Fire Regulation and Universal Design Compliance Results

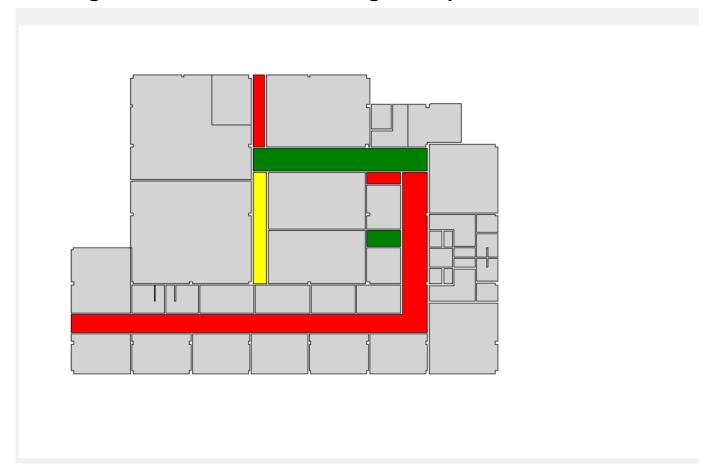
Corridor is not wide enough! Required width is 1.3 m!

Corridor is wide enough according to BR18. Required width is 1.3 m.

But it is not compliant with Universal Design principles. The recommended corridor width is 1.5 m.

Corridor is not wide enough! Required width is 1.3 m!

Corridor is not wide enough! Required width is 1.3 m!
